REMARKS

Applicant: Ta et al.
Application No.: 10/692,433

Fig. 3

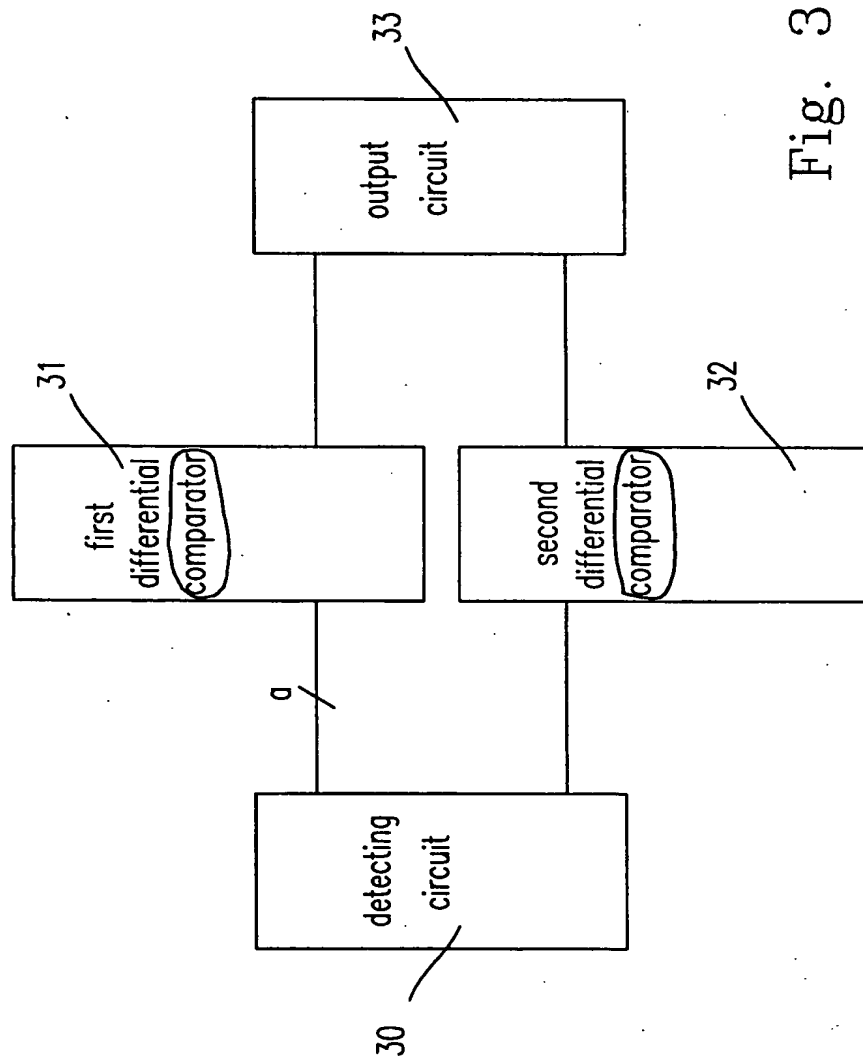
The “first differential comparator circuit” and “second differential comparator circuit” in Fig. 3 of the drawings of the present invention are replaced by “first differential comparator” and “second differential comparator” respectively according to the corresponding terms employed in the claims as originally filed.

Fig. 4

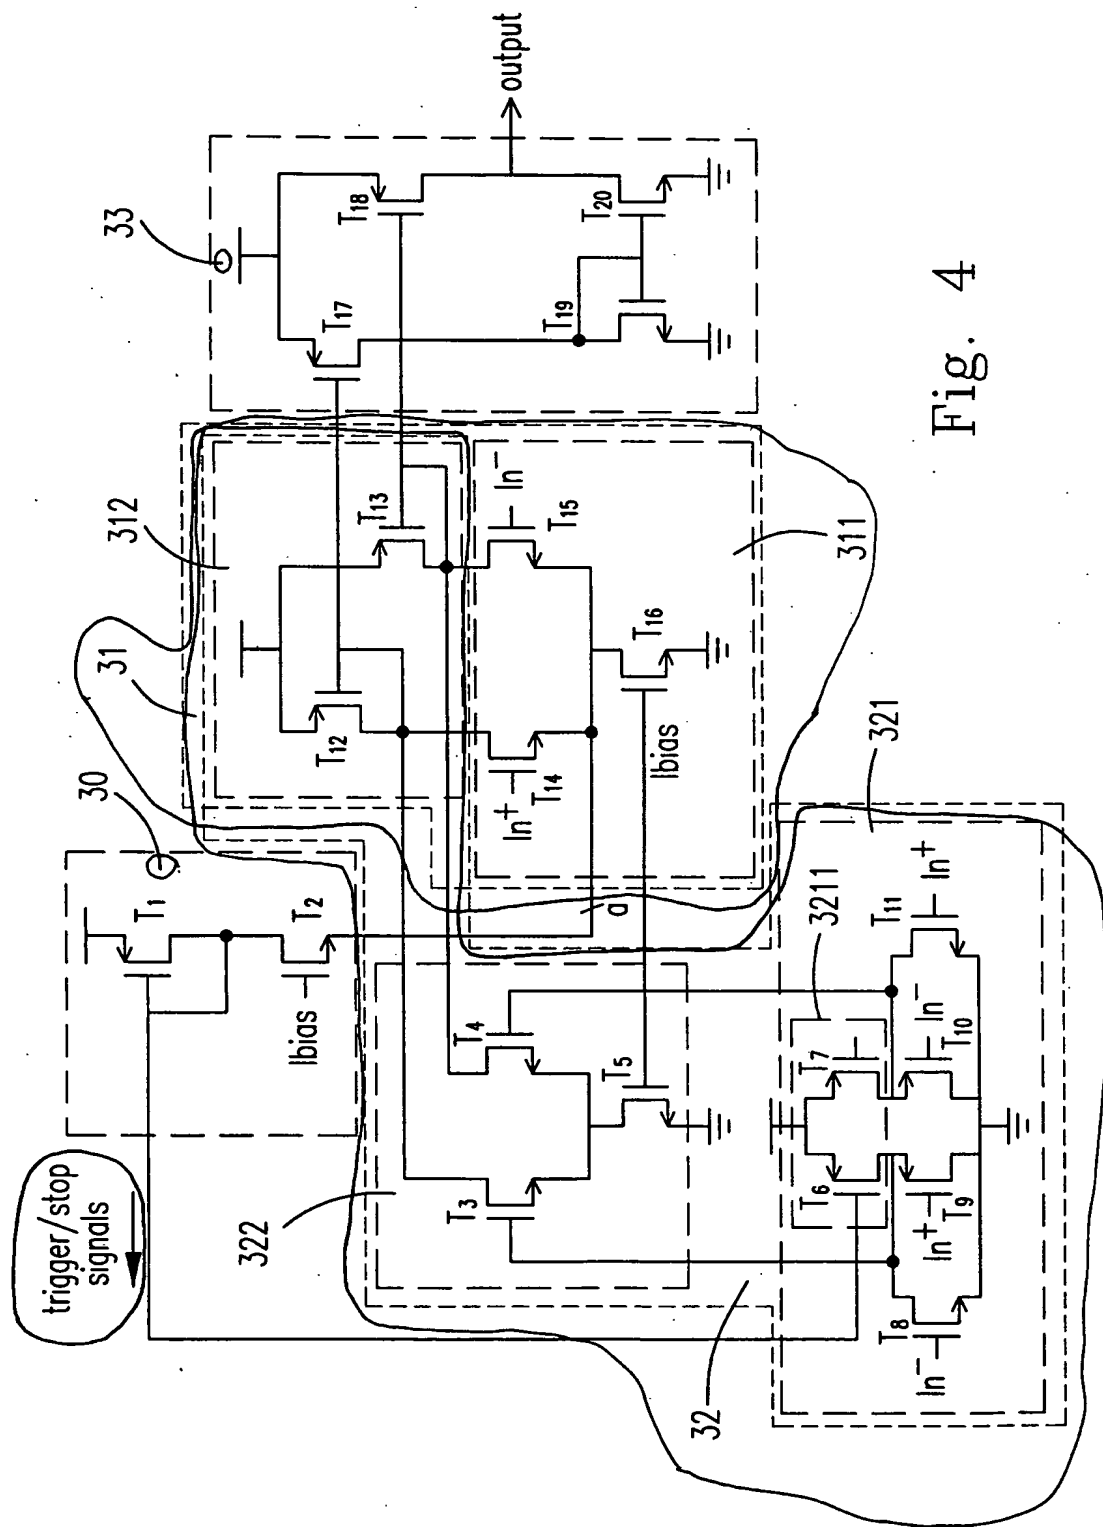
The Examiner requested that the trigger signal and the stop signal be shown in Fig. 4 of the present invention and that the Applicants explain how the voltage ranges are detected. Accordingly, the Applicants offer the following. The trigger signal is produced by the detecting circuit as disclosed in claims 1, 8, and 12 as originally filed, and the stop signal is also produced by the detecting circuit as described on paragraph [0035], line 5 of the specification as originally filed. Thus, the trigger/stop signals are marked at the output terminal of the detecting circuit as shown in Fig. 4. Furthermore, the operational status of the first operational receiving circuit (311) of the first differential comparator (31) is detected at the spot marked "a," as shown in Fig. 4 and described on paragraph [0031], lines 3-4 of the specification as originally filed. The operational principles regarding how the detecting circuit (30) can detect the status of the first differential receiving circuit (311), and how this "a trigger signal" can activate the second differential comparator (32) are further analyzed and described as follows.

Firstly, as shown in Fig. 4 of the present invention, one with the ordinary skill in the field would know that: (a) if $(\ln+ \& \ln-) > 2$, the first differential comparator (31) works ==> the voltage level of "a" is relatively high==>(the voltage

level of the output signal from the detecting circuit (30) to the pre-amplifier receiving circuit (321)) is relatively high (a stop signal) ==> the pre-amplifier receiving circuit (321) is off; and (b) if $(I_{n+} \& I_{n-}) < 2$, the first differential comparator (31) doesn't work ==> the voltage level of "a" is relatively low ==> (the voltage level of the output signal from the detecting circuit (30) to the pre-amplifier receiving circuit (321)) is relatively low (a trigger signal) ==> the pre-amplifier receiving circuit (321) is on. Secondly, "a stop signal" means that the voltage level of "a" is relatively high, and "a trigger signal" means that the voltage level of "a" is relatively low. Thirdly, from the above-mentioned description, the detecting circuit (30) can detect the status of the first differential receiving circuit (311) by sensing the voltage level of the marked place "a" to detect an input voltage of the detecting circuit (30) (an input signal of the detecting circuit (30)) as shown in Fig. 4 of the present invention.

Furthermore, as pointed out by the esteemed Examiner, the voltage level of the trigger/stop signals = $(V_{DD} - \text{transistor-connected diode drop})$, one with the ordinary skill in the field would know that when the voltage level of "a" (as shown in Fig. 4 of the present invention) is relatively low, the voltage drop of the transistor-connected transistor T1 is relatively high, and thus the level of the output of the detecting circuit (30) ($=V_{DD} - \text{voltage drop of T1}$) is relatively low (a trigger signal) firstly. Secondly, when the voltage level of "a" is relatively high, the

voltage drop of the transistor-connected transistor T1 is relatively low, and thus the level of the output of the detecting circuit (30) ($=V_{DD}$ - voltage drop of T1) is relatively high (a stop signal) secondly. Thus, when the voltage level of the output signal of the detecting circuit (30) is lower enough (a trigger signal), the transistor T6 of the level shift circuit (3211) would be turned on instead of always being turned off by a relatively higher positive voltage as considered by the esteemed Examiner. For the reasons set forth above, Applicants request withdrawal of the objections as well as the rejection of claim 1 under 35 U.S.C. § 112, first paragraph.

All the transistors are labeled, and the numeral references of 31 and 32 as well as the trigger/stop signals are marked in Fig. 4 of the present invention to clarify the contents of the present invention as the esteemed Examiner has suggested.
